## Statement Letter

The HW version for new product is P2. We declare both FE5RWR131 P1 and P2 HWs support same bands, same category configuration, for FE5RWR131 P2, there is no components/BOM change, only minor PCB layout changes.

### 1). Layout change zone in green:

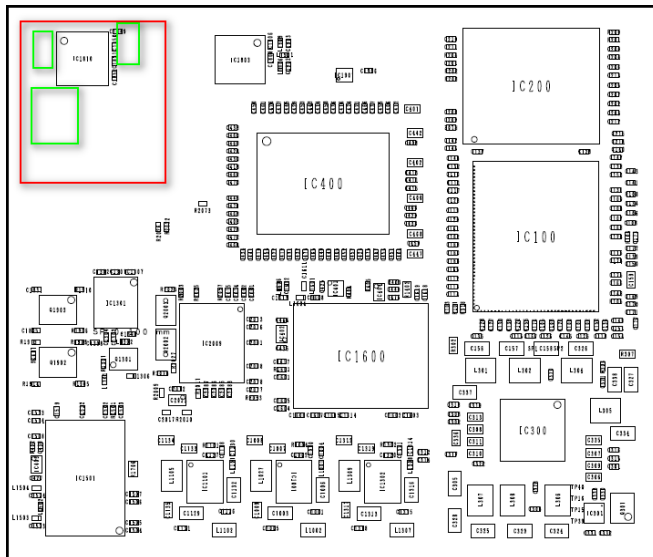
Due to the components package size (blow 3 green zone which used for other variant with the same PCB) changed, the trace in yellow zone should be tuned. But the frame would not be changed.

### 2). Detail changes:

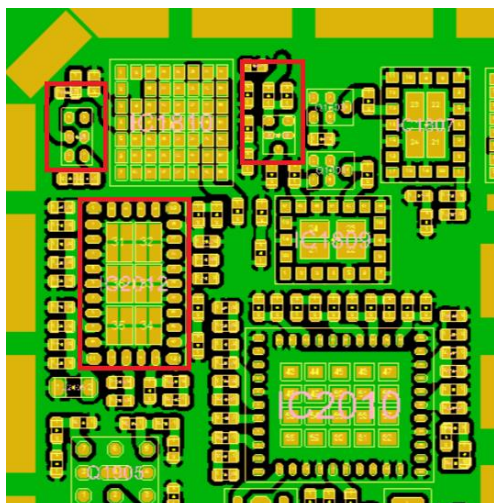
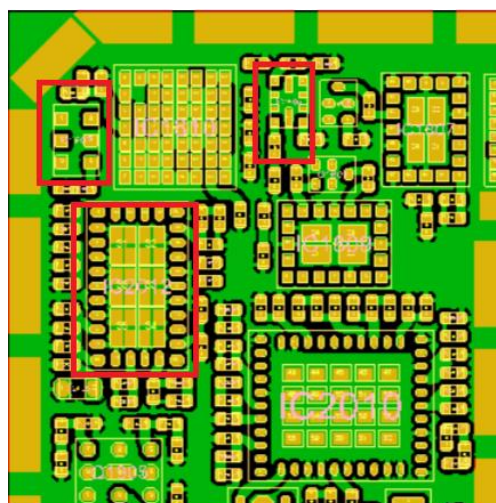
For the variant FE5RWR131 P1/P2, there 3 components not used, so the layout change around these components has no impact to the P2 design.

The above changes will not affect the original RF performance of the product
